CITY PLAN COMMISSION**THURSDAY, MARCH 2, 2023****FILE NUMBER:** S223-076**CHIEF PLANNER:** Mohammad H. Bordbar**LOCATION:** Dowdy Ferry Road, south of Plainview Drive**DATE FILED:** February 6, 2023**ZONING:** IR**CITY COUNCIL DISTRICT:** 8 **SIZE OF REQUEST:** 20.172-acres **MAPSCO:** 68M**APPLICANT/OWNER:** A&F Industrial, LLC

REQUEST: An application to create one 20.172-acre lot from a tract of land in City Block 1/8525 on property located on Dowdy Ferry Road, south of Plainview Drive.

PRELIMINARY PLAT

A & F ADDITION

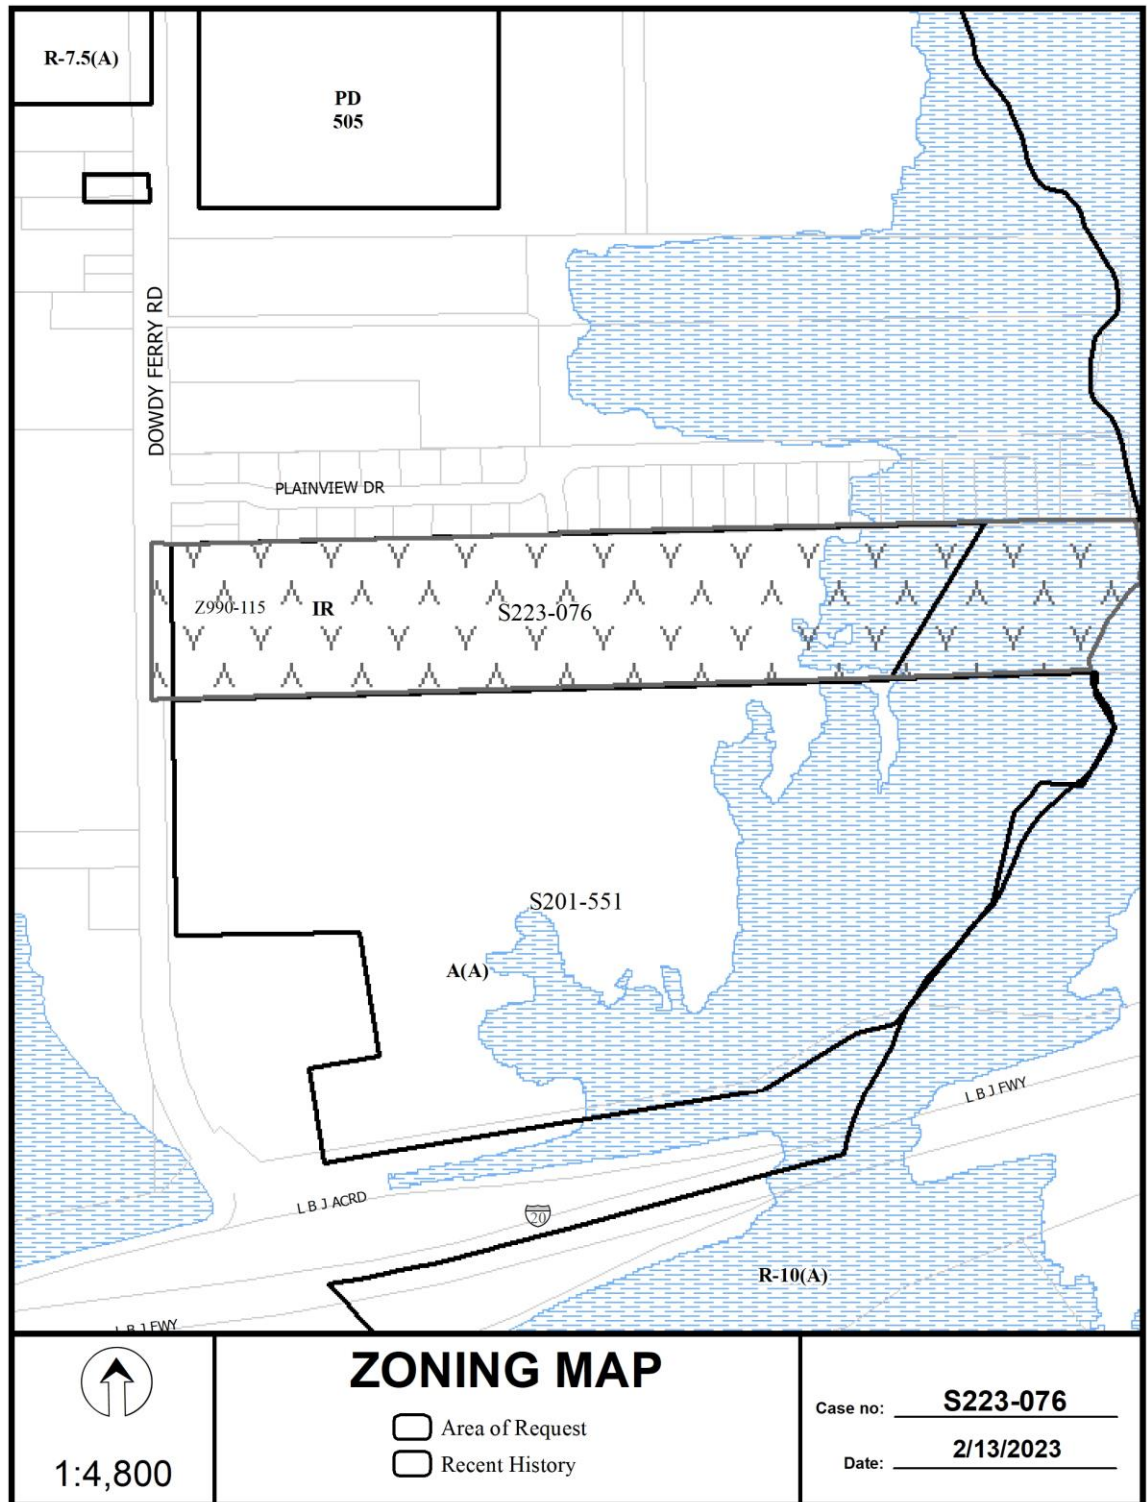
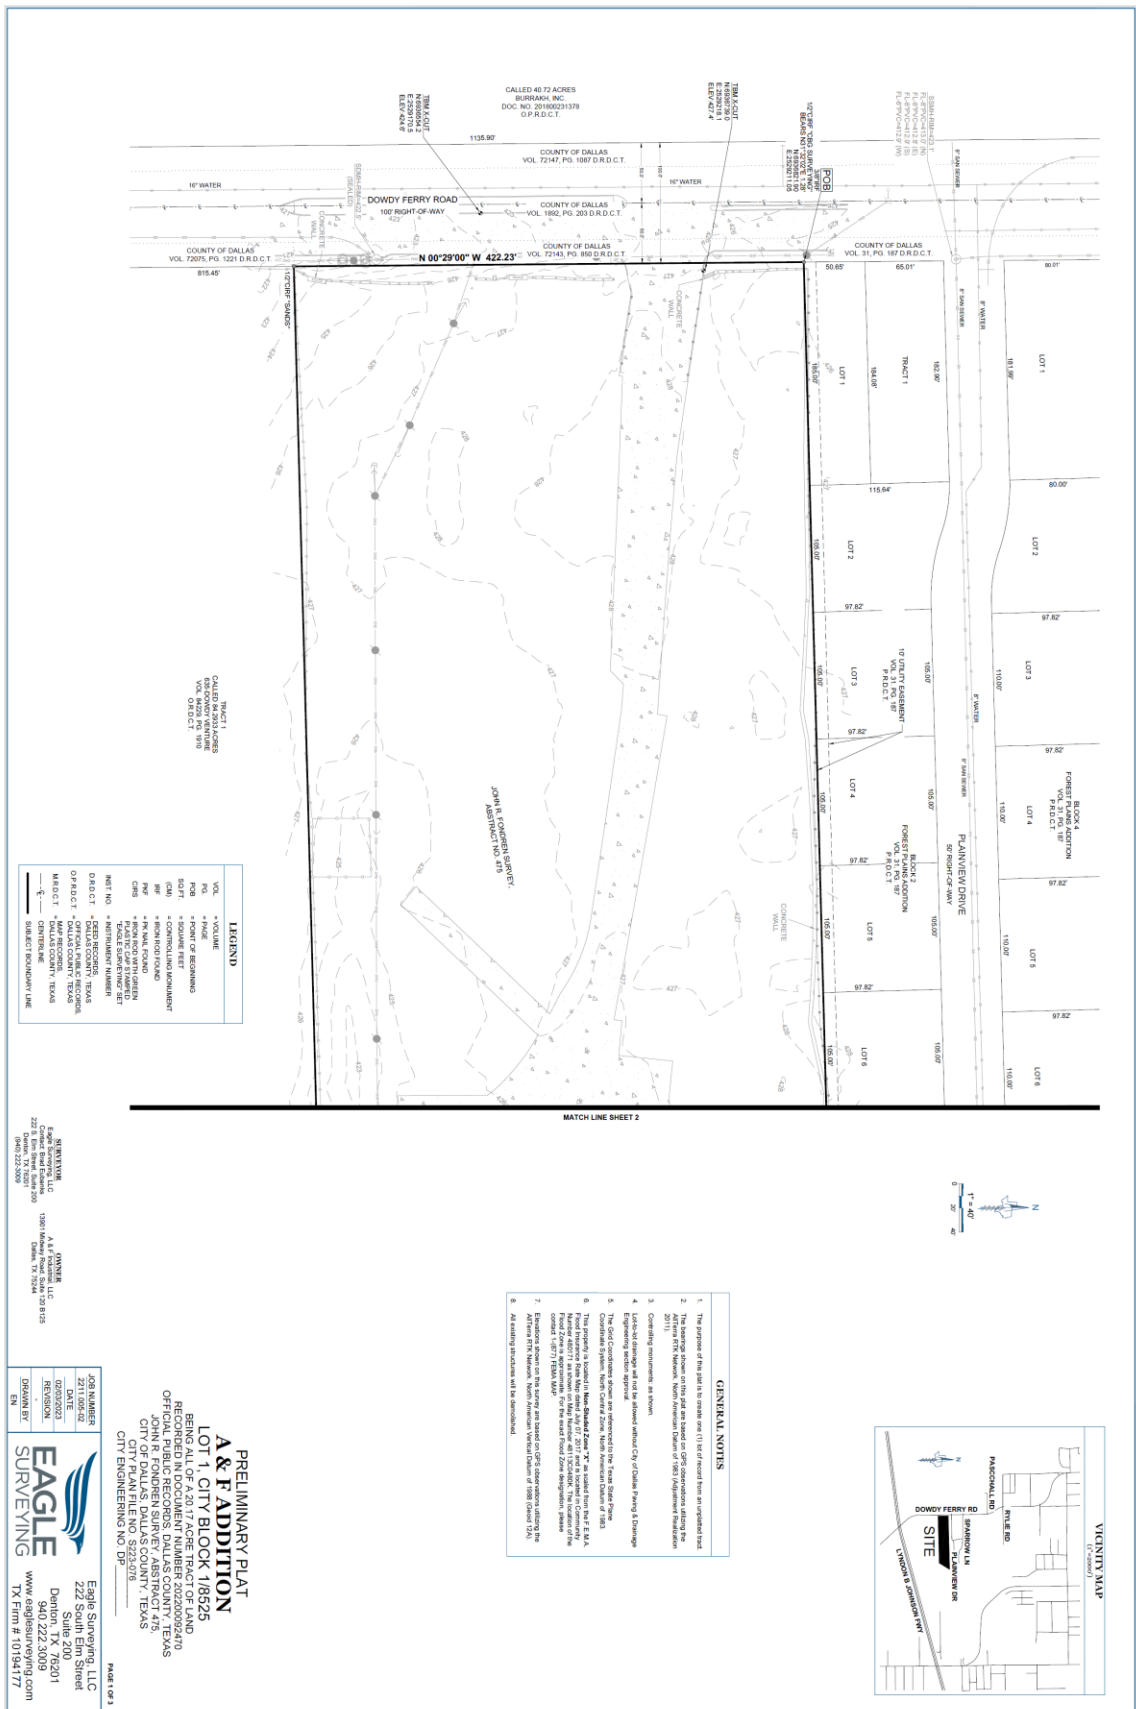
STAFF RECOMMENDATION: The request complies with the requirements of the IR Industrial Research District; therefore, staff recommends approval of the request subject to compliance with the following conditions:

12. Submit a full set of Civil Engineering Plans (drainage, paving, street signage/marketing/lighting) prepared per City Standards by a licensed (TX) Professional Engineer to Engineering Division in Room 200, Oak Cliff Municipal Center (i.e., 311T/DP). Additions and alterations to the public infrastructure require approval and may require private development contracts with bonds. 51A-8.102 (c); 8.601(b)(4),(5),(6),(7),(8),(9)
13. Detention may be required if the capacity of available outfall is not adequate to carry the developed runoff. Section 51A-8.611(c).
14. Place a note on the final plat stating "Lot-to-Lot drainage will not be allowed without proper City of Dallas Engineering Division approval" 51A 8.611(e)

15. Provide Right-Of-Way, design and construction for a deceleration/acceleration Lane if the Traffic Impact Study (TIS) justifies this need.

16. On the final plat, determine the 100-year water surface elevation across this addition.
17. On the final plat, dedicate floodway easement, floodway management area or floodway easement (within common area), with the appropriate easement statement included on the face of the Plat. 51A 8.611(d); DWU Floodplain Management; Drainage Design Manual Addendum V
18. On the final plat, include additional paragraph in Owner's Certificate (pertaining to the floodplain). 51A 8.611(d); DWU Floodplain Management; Drainage Design Manual Addendum V
19. On the final plat, specify minimum fill and minimum finished floor elevations. *Section 51A-8.611(d), Trinity Watershed Management.*
20. On the final plat, show the natural channel set back from the crest of the natural channel. *Section 51A-8.611(d), Trinity Watershed Management.*

21. Prior to submission of the final plat, set floodway monument markers and provide documentation that the monuments have been set. *Section 51A-8.617(d)(1), (2), (3), and (4)*
22. Provide information regarding Fill Permit or Floodplain Alteration Permit if such permit is applied for.

23. Prior to final plat, submit a completed final plat checklist and all supporting documents.
24. On the final plat, chose a new or different addition name. Platting Guidelines.

25. Engineer must furnish plans for water and sanitary sewer. Developer must furnish a contract for water and sanitary sewer. Sections 49-60(g)(1) and (2) and 49-62(b), (c), and (f).
26. Additional design information is required for assessment. Site plan must be submitted showing proposed development, building finished floor elevation, development, existing mains – including downstream manhole, and proposed water and wastewater service locations. Submit water/wastewater engineering plans to 320 E. Jefferson Blvd., Room 200, Attention: Water and Wastewater Engineering.

27. On the final plat, identify the property as Lot 1 in City Block A/8525. Ordinance 1A, Page 131 pages 131-148, Section 2 (passed August 13, 1872).
